Fakir Fashion Ltd

Dohargaon, Balipara, Rupgonj, Narayanganj
(+23.784289N, 90.587415E)

26 October 2013

Building Observations

Cracking in beams and slabs

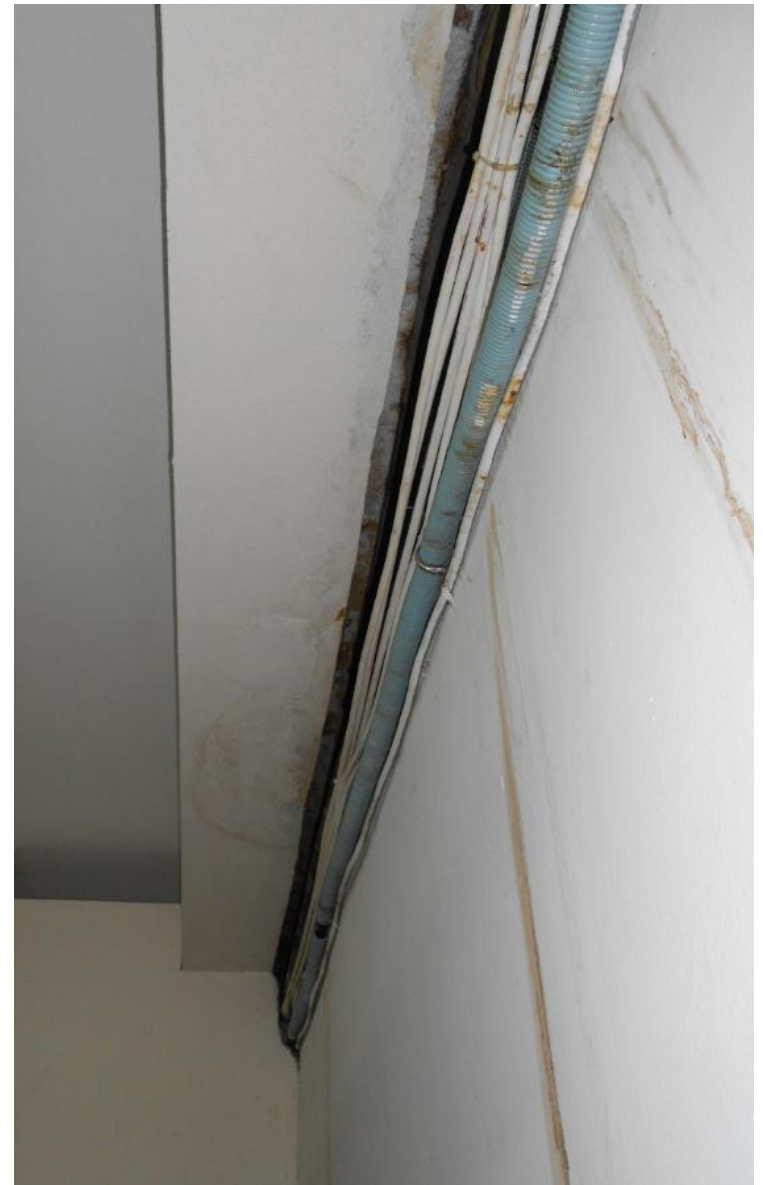
Repaired cracking in beams and slab

Engineer is to perform/provide calculations to prove slab and beam are satisfactory for factory loading, and permanent build up load, and (if required) :

- Reduce loads by vacating floors
- Reinforce structural elements
- Produce loading plans

Lateral Stability

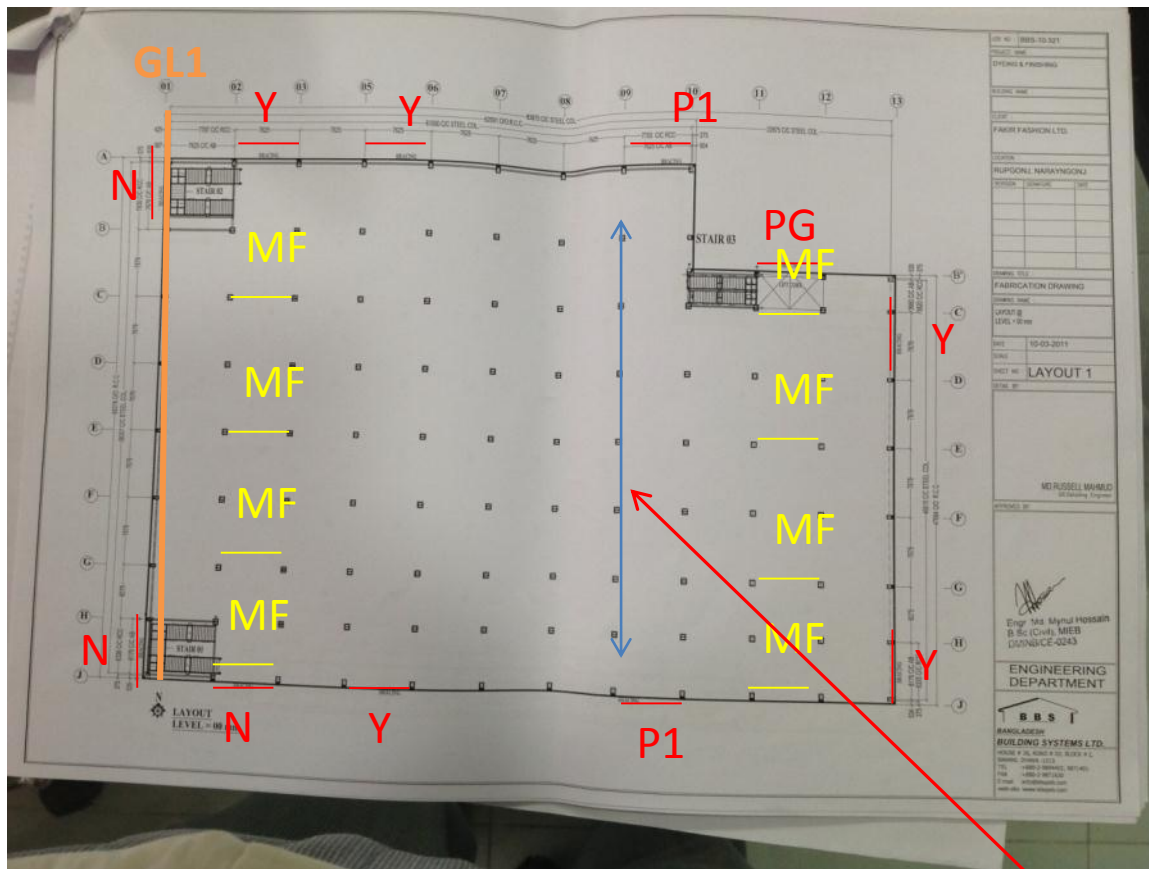
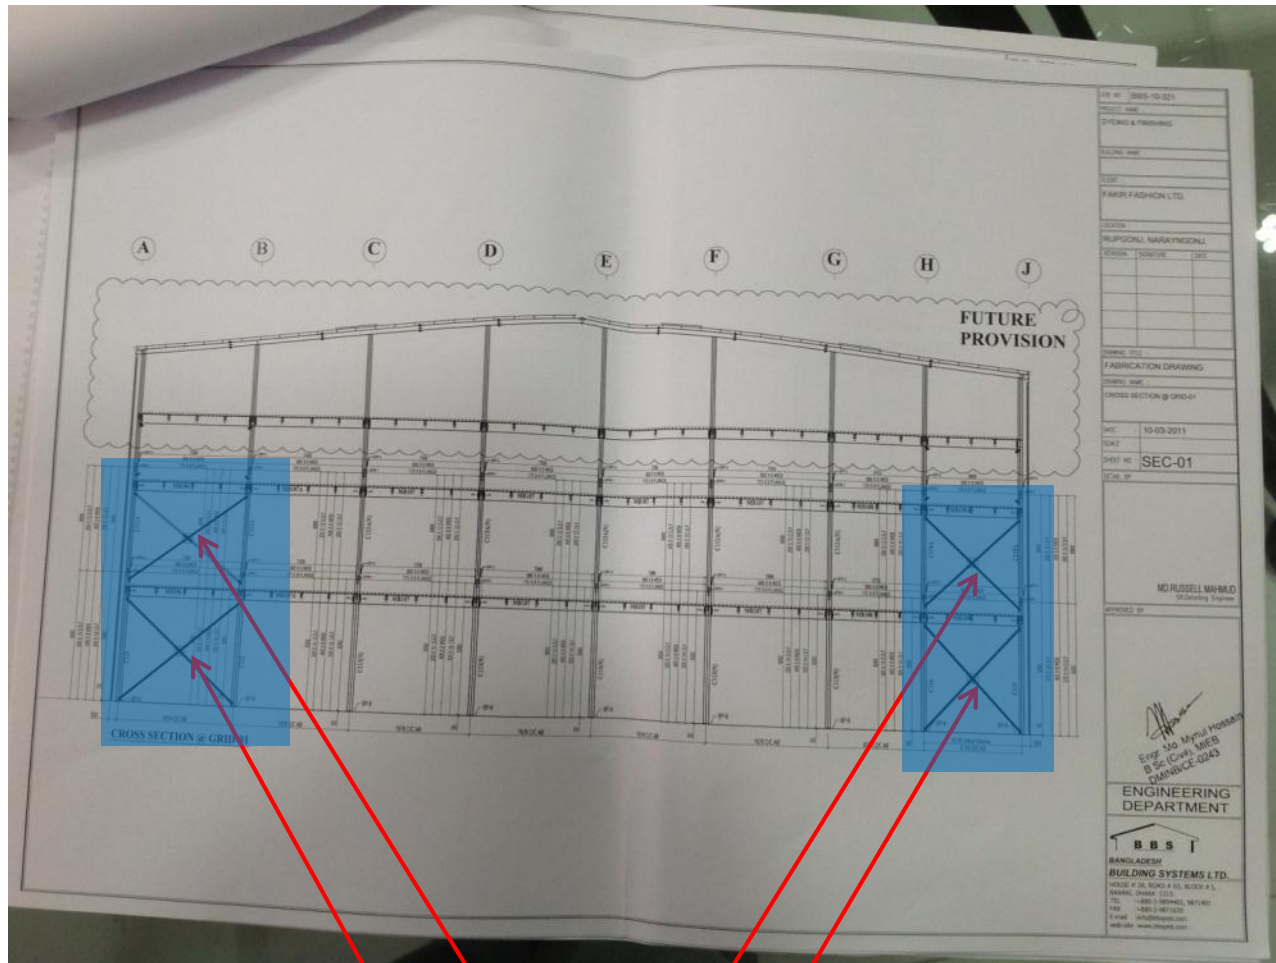
Y = X bracing on Ground and First floors

PG = X bracing only present on Ground Floor

P1 = X bracing only present on 1st Floor

N = X bracing not present on either floor

MF = additional “moment frames” in bays both floors

Building only 2 of 4 stories and hence all bracing may not be required at this stage however lack of X bracing along Gridline 1 (GL1) needs to be justified.

Lateral stability in this direction to be justified

General floor beam arrangement

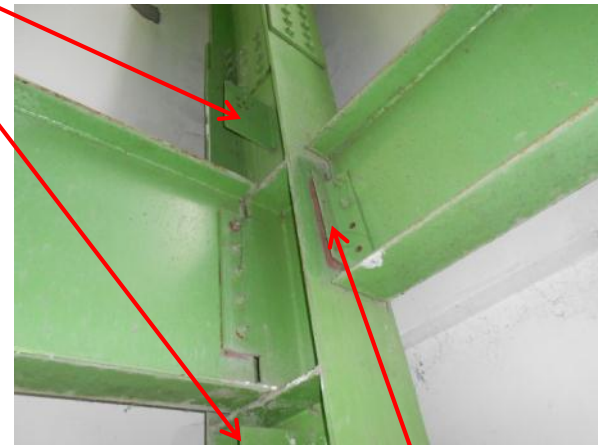
Missing X bracing along GL1 – cleat plates present

**Additional moment frames (MF)
– purpose and capacity unknown**

Modified X bracing

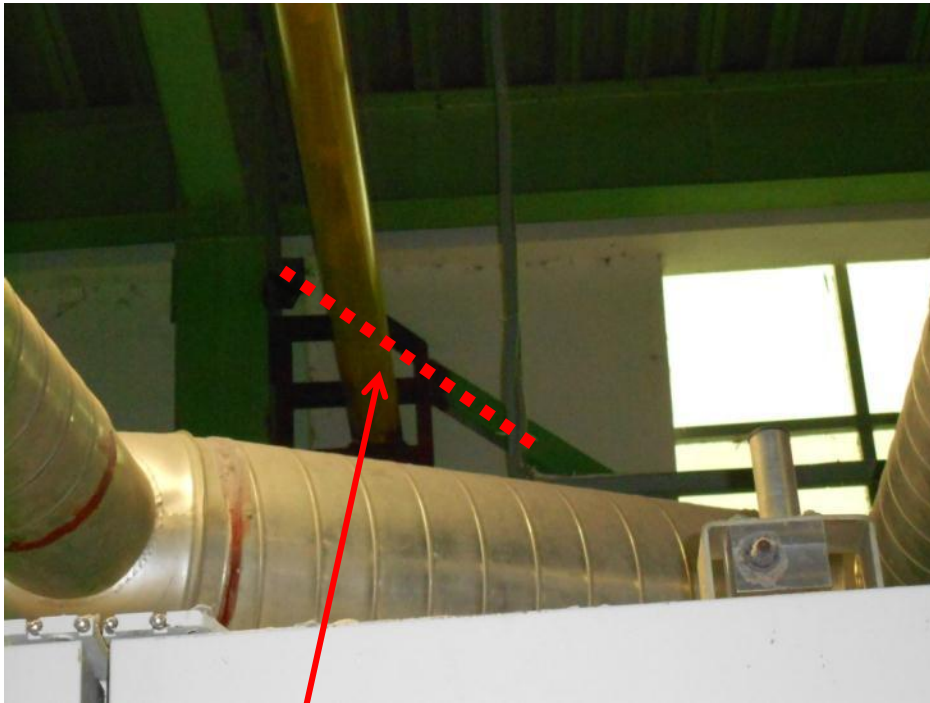
**Missing bolts to angle cleat –
stair GL 1/A**

Bracing at Gridline J / 9-10 Level 1 has been cut and re-welded to pipe support steelwork. Bracing is the principal element and must be continuous. Rectify bracing and modify pipe support.

Façade connection to structure

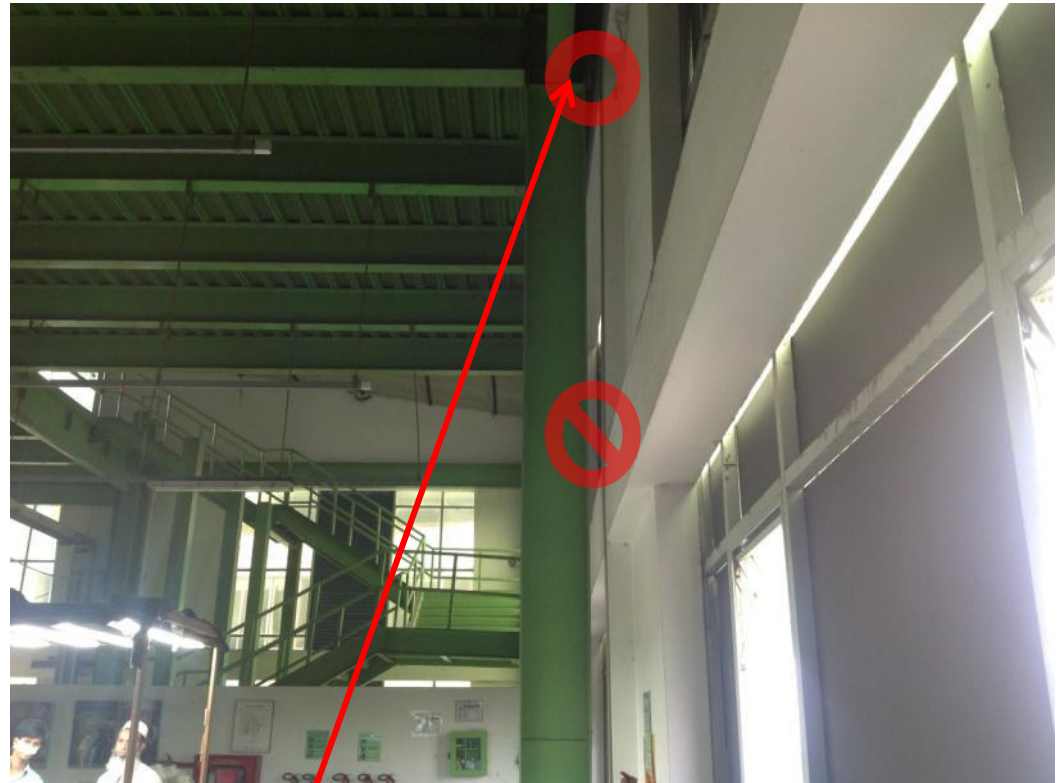
External façade (RC beam and column with glazing infill) appears to be connected to the steel frame at floor levels only (ie Ground, First and Second (current roof). No structural drawing of façade provided. Concern with connection of façade to steel structure subject to lateral load.

Façade connected at floor levels – not connected at intermediate façade beam level however no structural drawings of façade available to confirm structural arrangement for façade

Exposed steel work durability

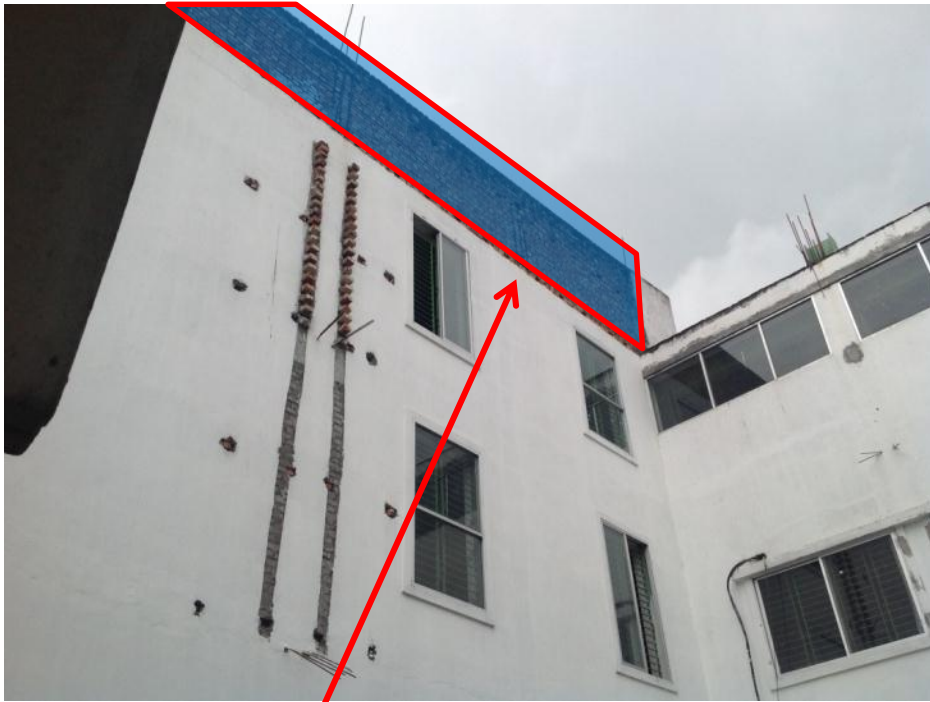
No falls on Level 2 (current roof) leads to water ponding. No evidence of water penetration to below however durability of steelwork at floor level is a concern for future expansion upwards.

Additional Structure

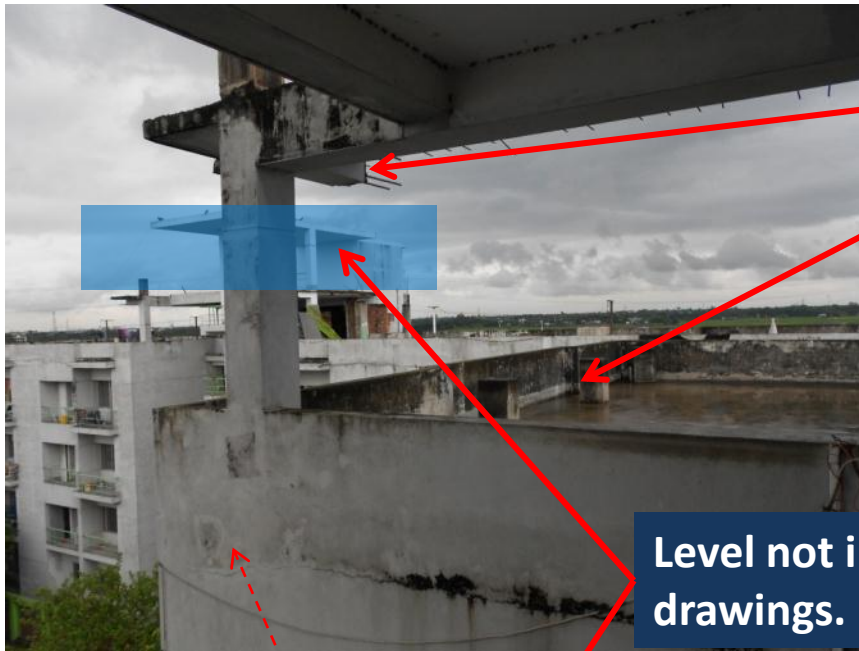
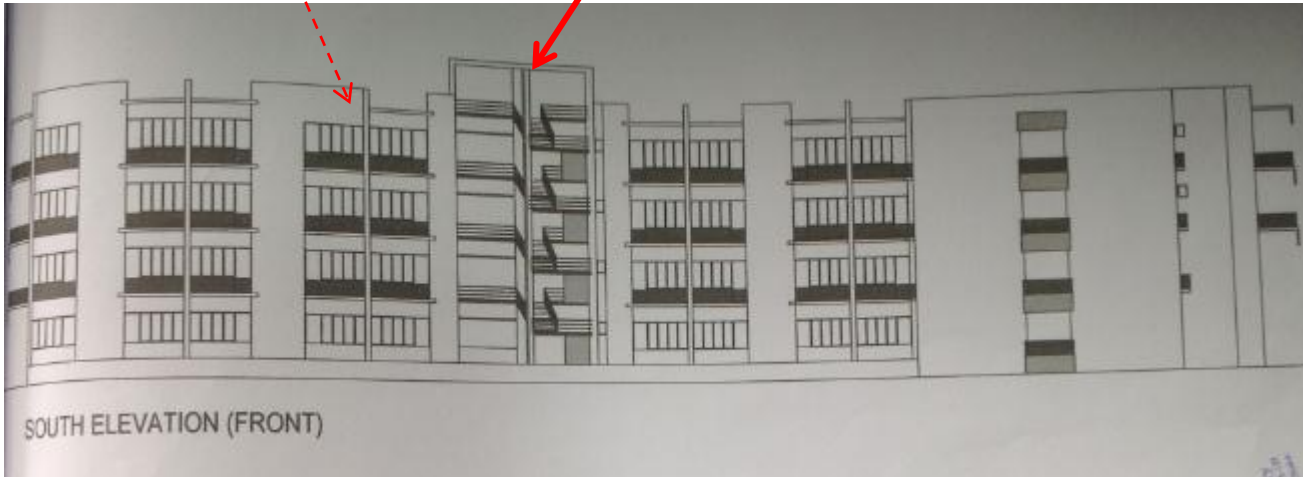
Evidence of possible 5th floor preparation (Permit allows 4 stories)

Level not indicated on permit drawings.
